**2017 Edwards Aquifer Recharge Zone (EARZ) Cured In Place Pipe (CIPP) Construction Contract
Solicitation Number: CO-00130
Job No.: 17-4536**

**ADDENDUM 2
June 5, 2017**

DR 242 LOOP 1604 LARGE DIAMETER SEWER REHAB PROJECT
SANITARY SEWER PLAN VIEW

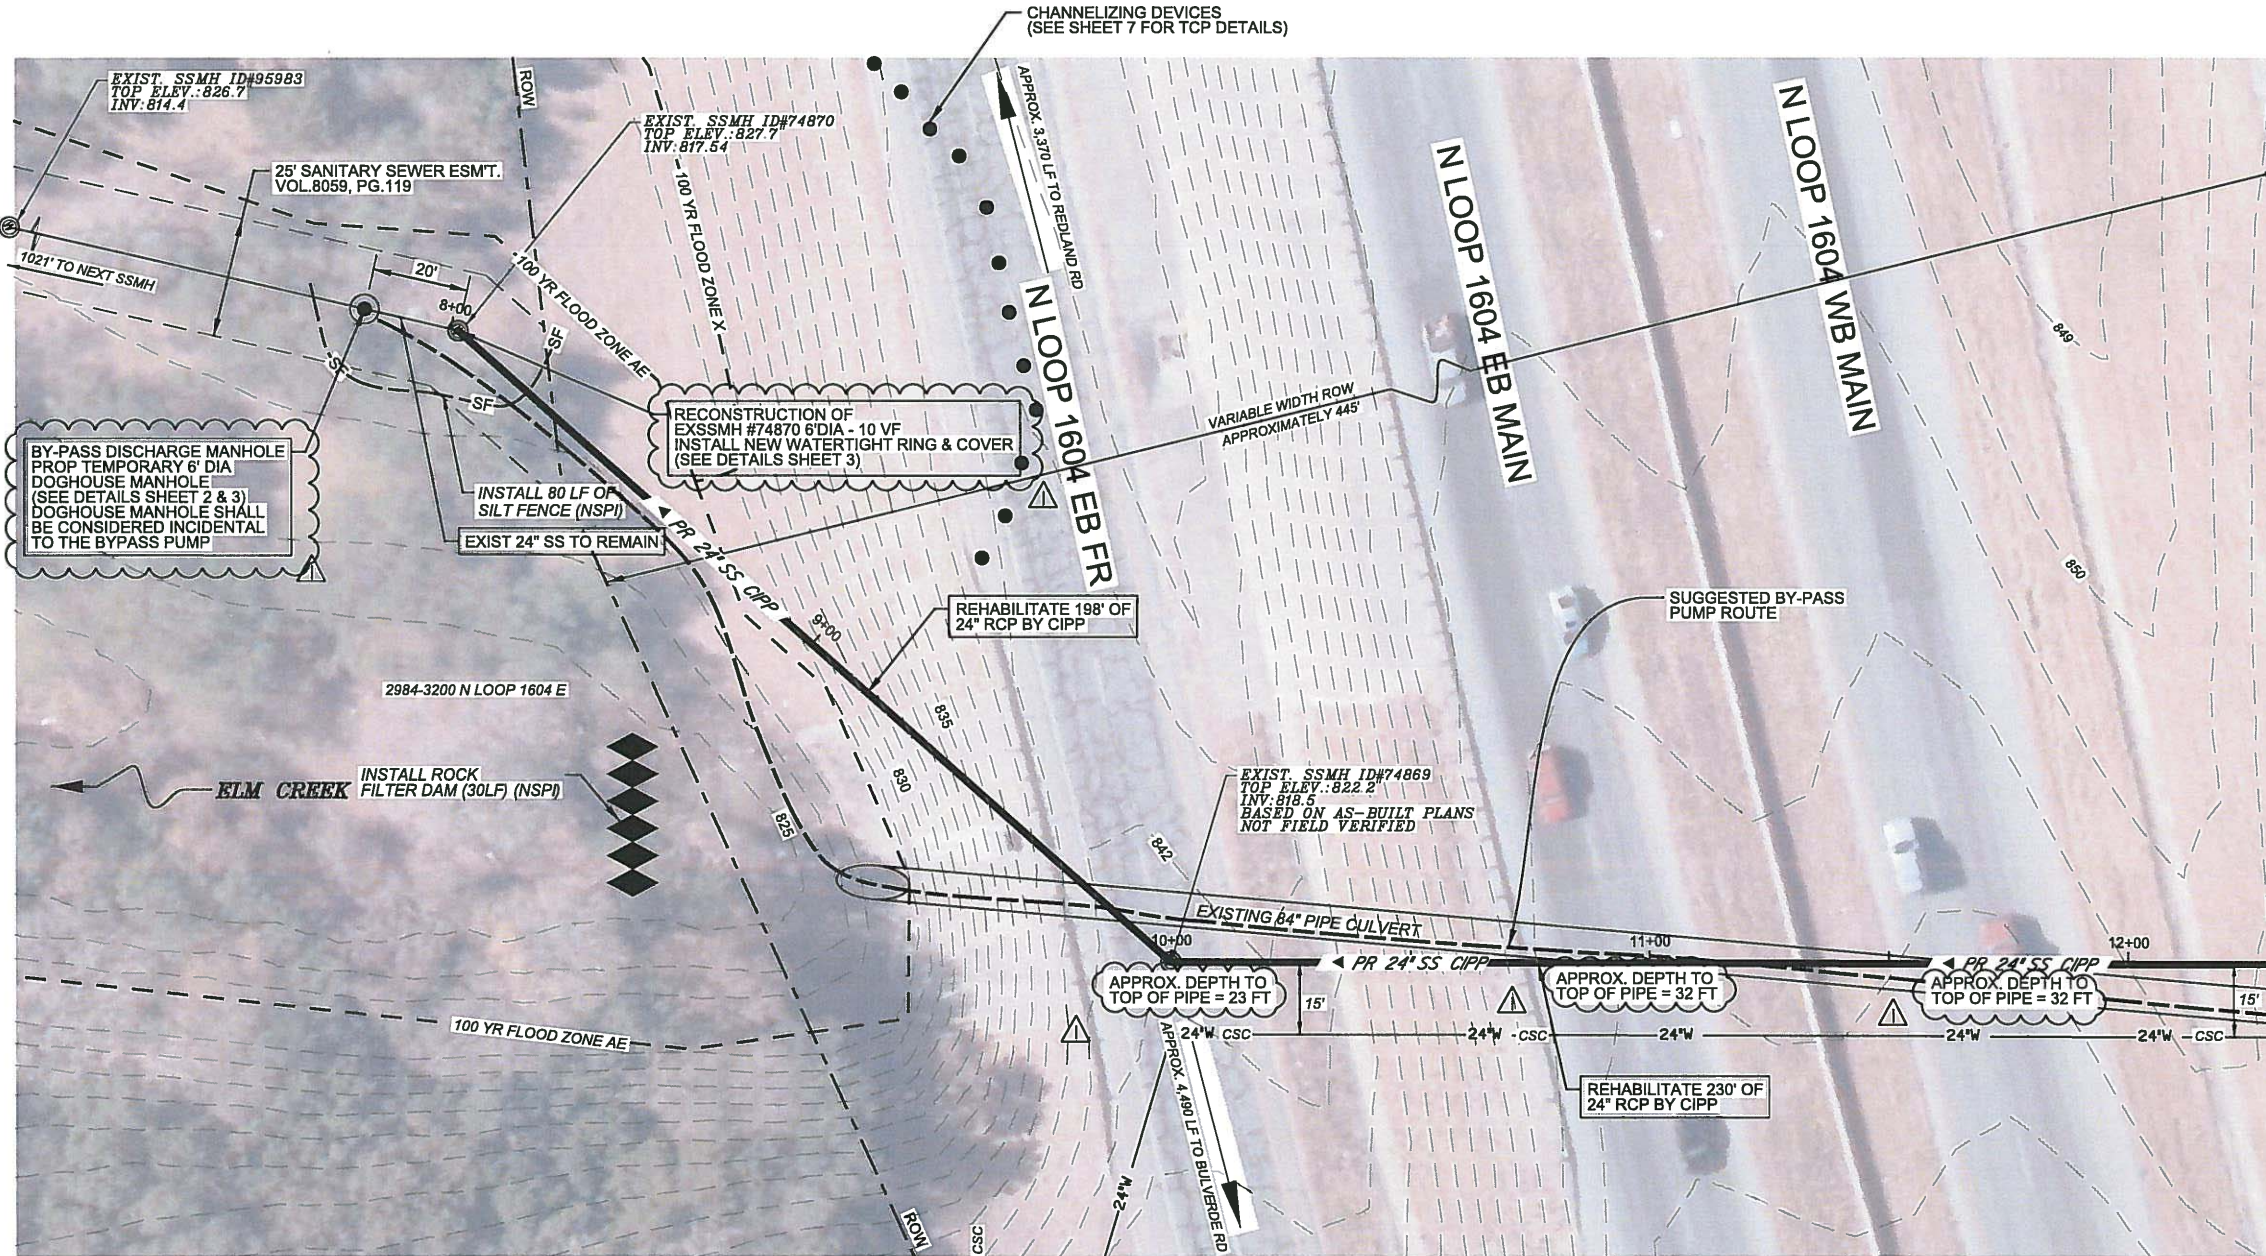
- 3. Question: Please provide approximate pavement elevations along the pipe alignment on the main lanes of Loop 1604 in order that accurate liner designs can be performed and subsequent costs for materials, etc. be utilized for a responsible bid. Page 9 (sheet 4) of the plans.**

12. Loop 1604, Sheet 4: Project legend is revised to change "Proposed UV CIPP" to "Proposed CIPP", and added depth data, revised quantity table, revised manhole callouts. Remove and replace sheet 4 in its entirety with the revised sheet attached.

Response: Plan sheets have been revised to include depth of cover information. Please see Changes to Plans as part of this Addendum.

DR 242 LOOP 1604 LARGE DIAMETER SEWER REHAB PROJECT
SANITARY SEWER PLAN VIEW

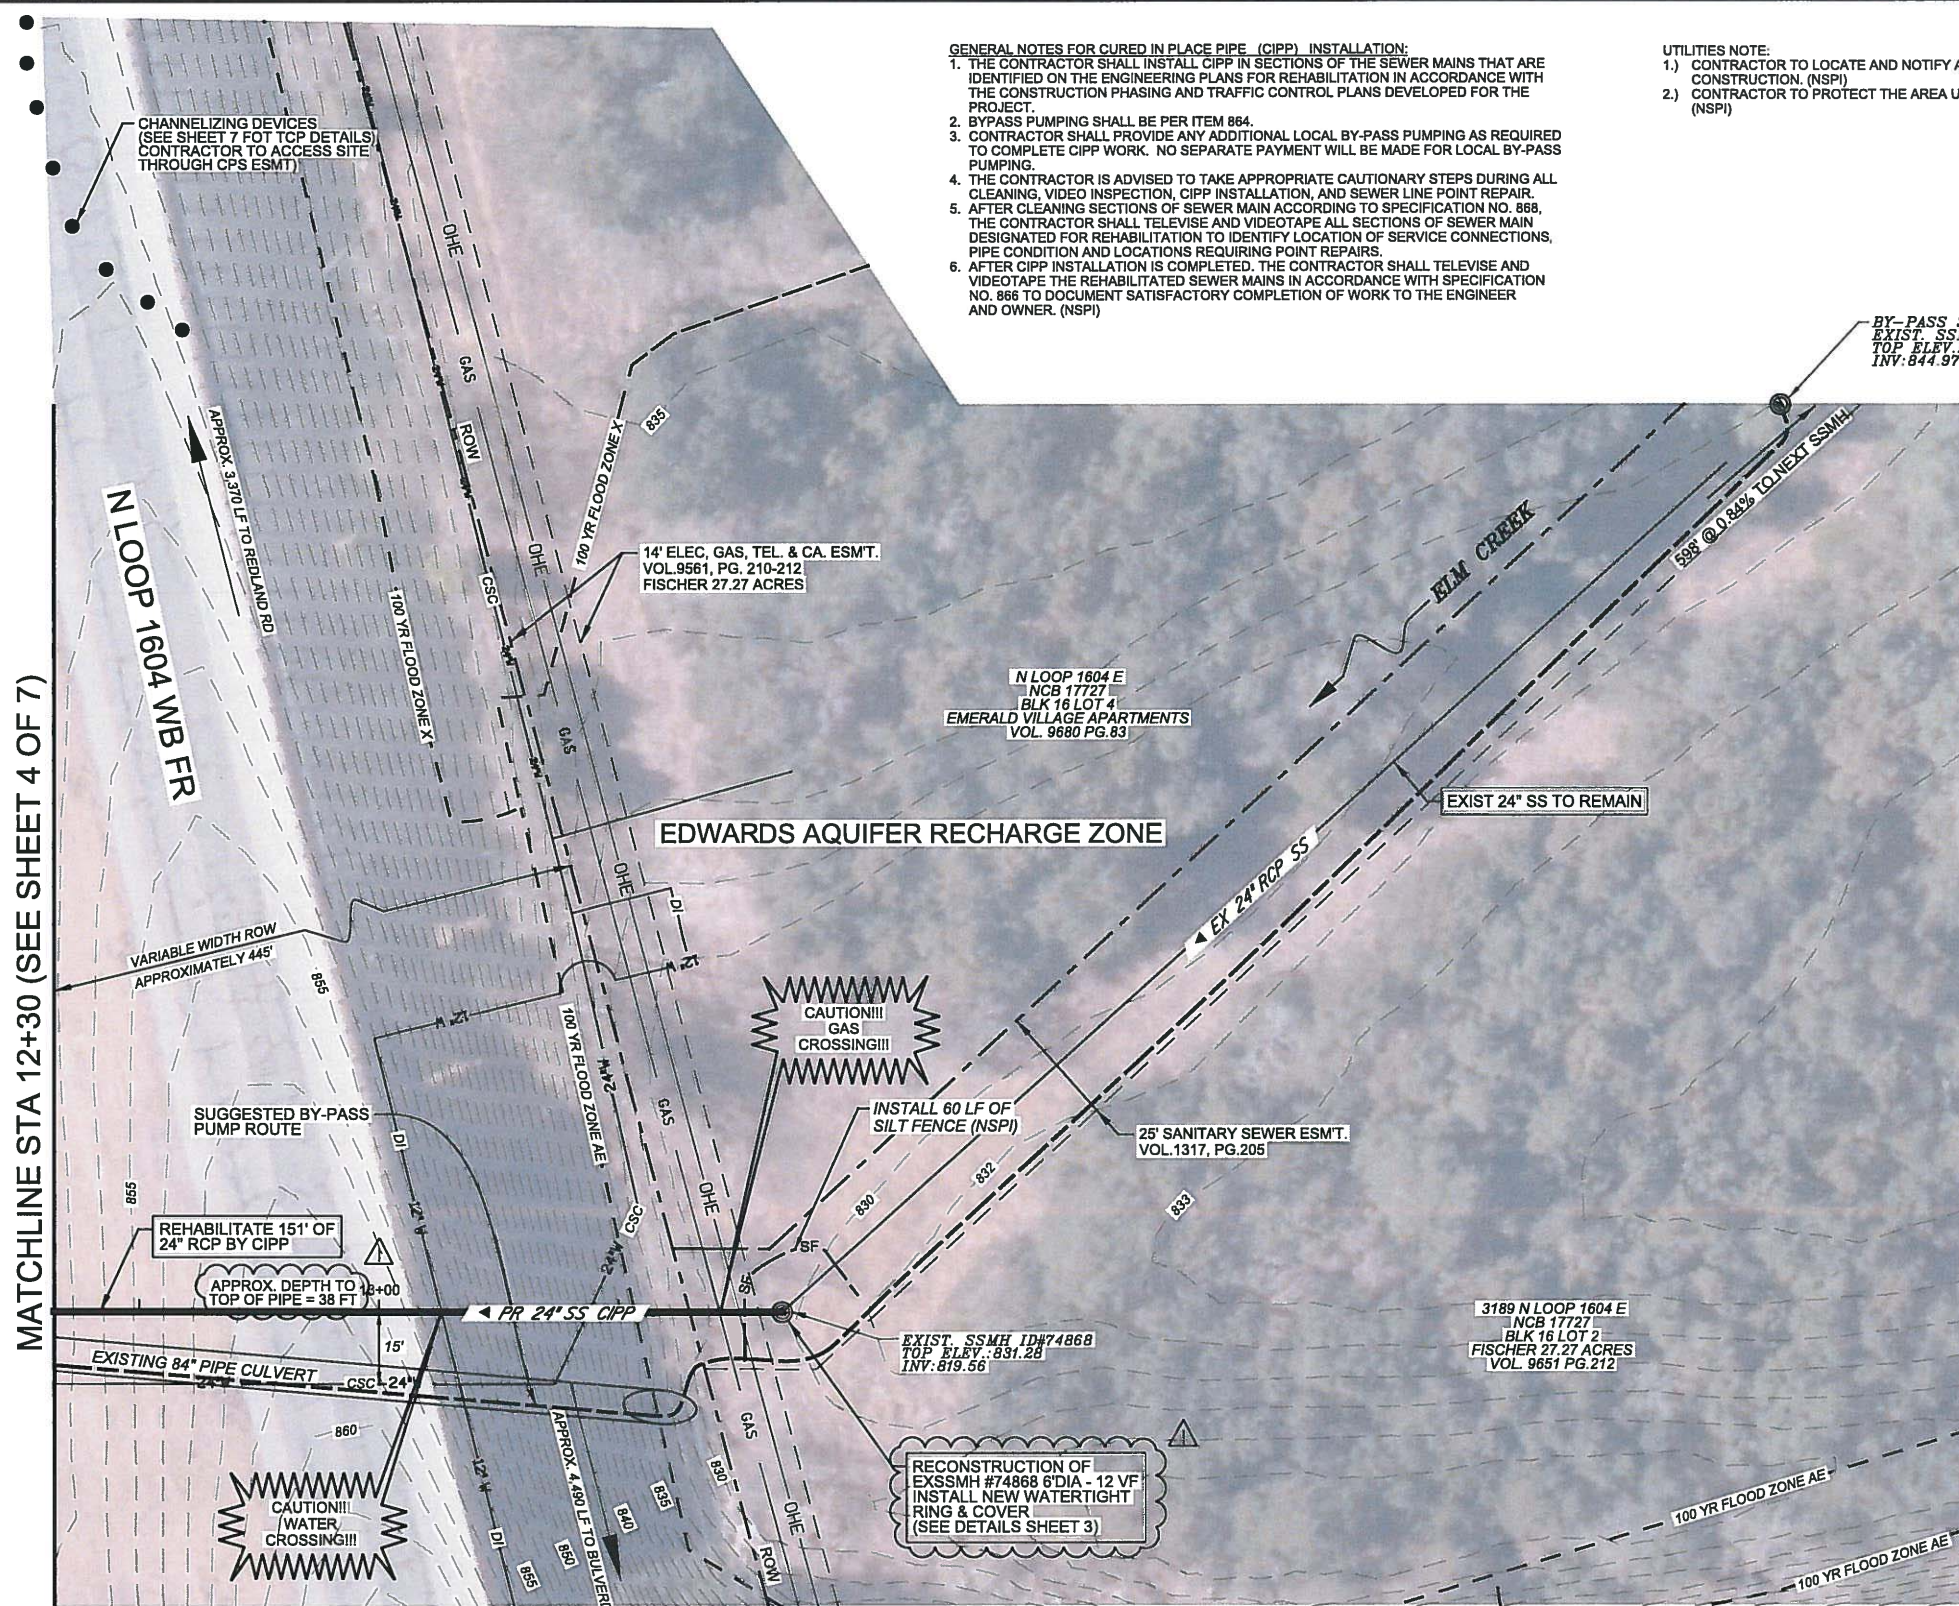
13. Loop 1604, Sheet 5: Project legend is revised to change "Proposed UV CIPP" to "Proposed CIPP", and added depth data, revised quantity table, revised manhole callout. Remove and replace sheet 5 in its entirety with the revised sheet attached.
